From: Caroline A. Richter
To: [Ballew, Cassie](#)
Cc: [Ty K. Wyman](#); [Linda K. Odermott](#)
Subject: Design Commission - Written Comment re 3415 SE 62nd Avenue (Case File LU 17-144195 DZ)
Date: Thursday, February 15, 2018 3:10:57 PM
Attachments: [DCAPDX-2617540-v1-Design Commision co Cassandra Ballew re 3415 SE 62nd Avenue - Case File LU 17-144195 DZ \(2-15-18\).PDF](#)
Importance: High

Re: 3415 SE 62nd Avenue at SE Powell Boulevard
BDS Case File No. LU 17-144195 DZ
Our File No.: NOR204-1

3333 SE 62nd

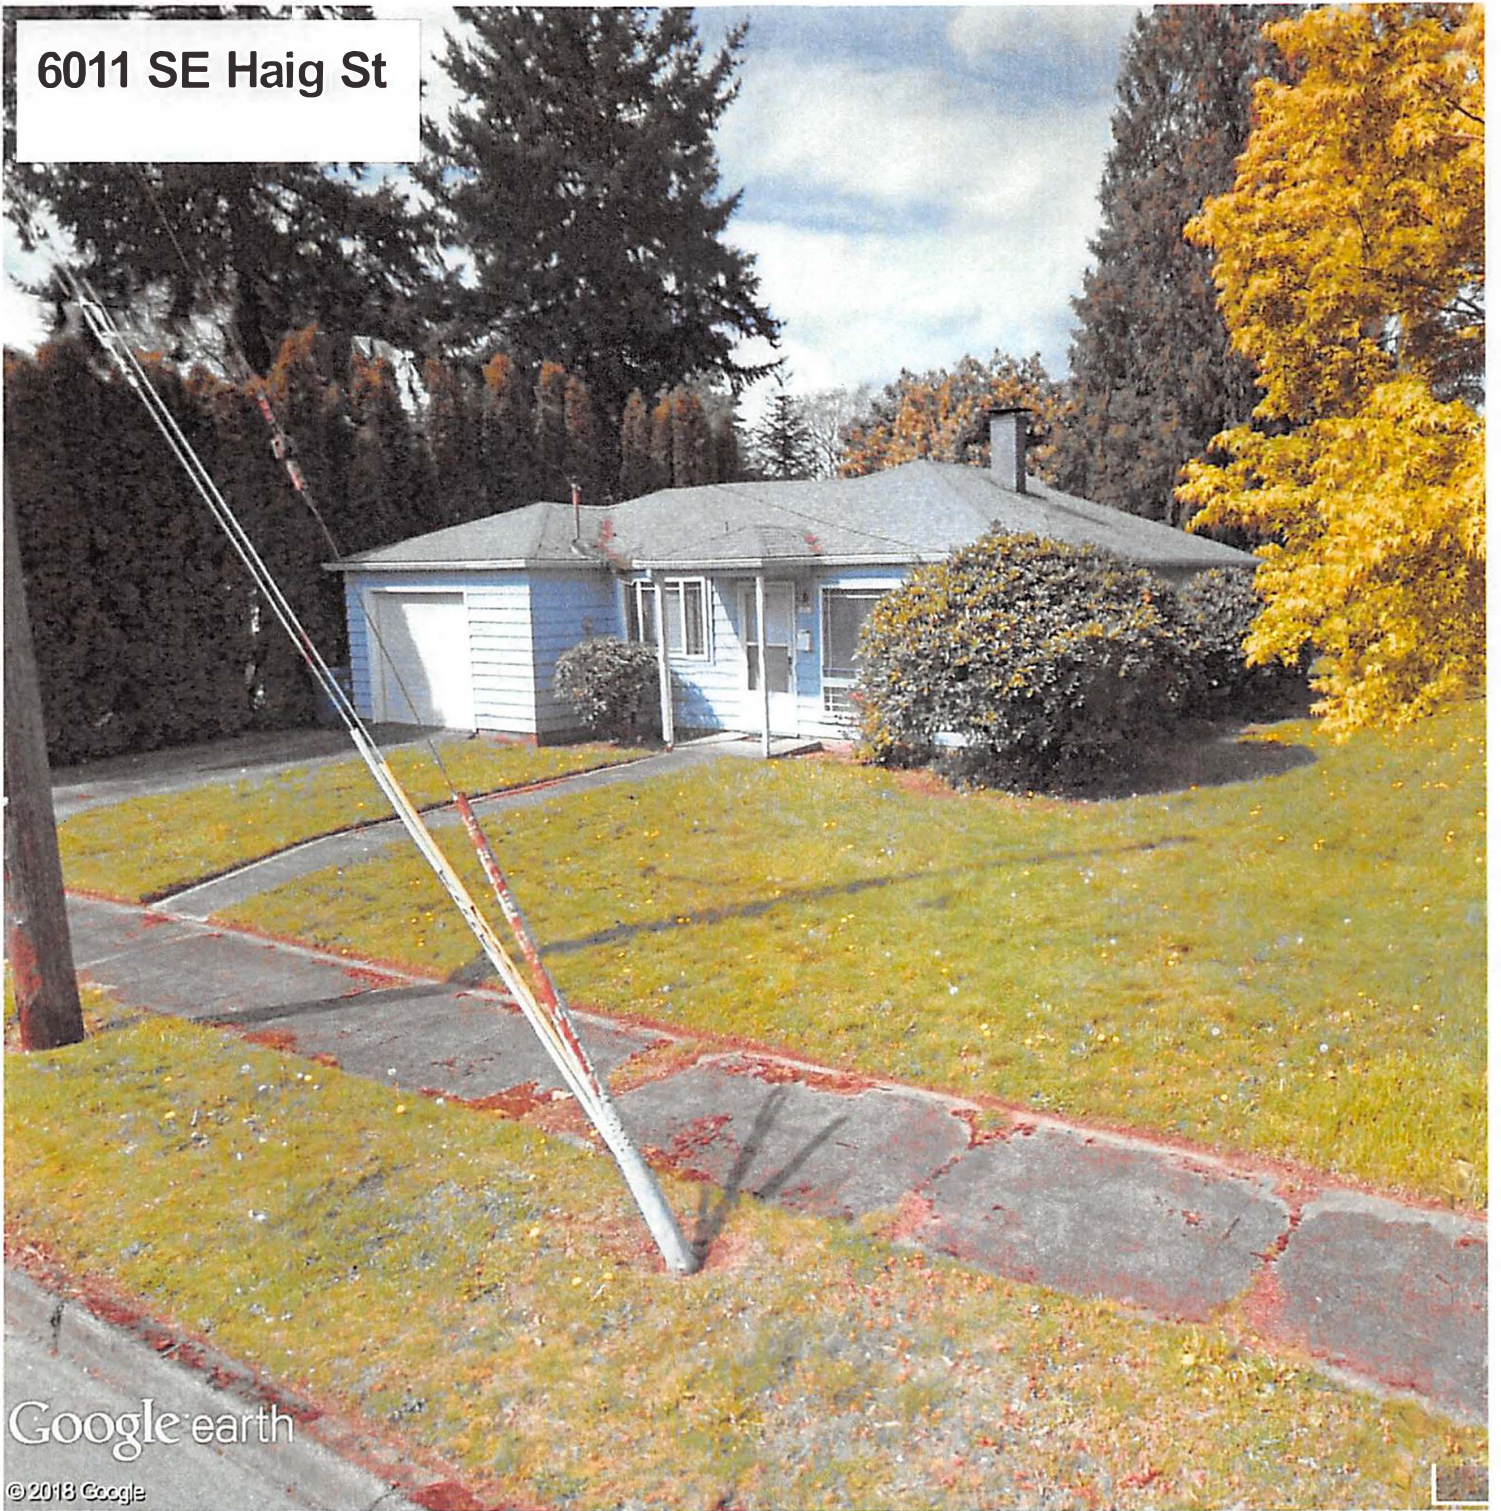
1. To the north sits 3333 SE 62nd Ave., built in 1952 and pictured in Ex. C. Stacie and Greg Greer own and reside here. They testified in opposition. Their home is a one-story design, with a distinct hip roof.
2. To the northwest sits 6011 SE Haig St., built in 1953 and pictured in Ex. D. Owned by Carol Cochran, it also features a single one-story design with hip roof.
3. Immediately to the west is 6010 SE Haig St., built in 1924 and pictured in Ex. E. Like the Greer and Cochran homes, this is a single-story design; it features a low-slope roof, though in a half-hip design.
4. To the east is 3408 SE 62nd Ave., built in 1922, in which Laura Claar resides and pictured in Ex. F. Like the Greers, Ms. Claar testified in opposition. Her home is also one story, featuring a craftsmen style with front gables and deeply overhanging, open eaves with distinctive support brackets.

So, each adjoining residence – the focus of the compatibility test – is one story featuring a hip roof. The applicant has taken steps to mitigate the boxy nature of its design, but mitigation is not relevant to compliance with PCC 33.284.050.A. All the landscaping in the world will not harmonize the applicant's roof line with these hip roofs.
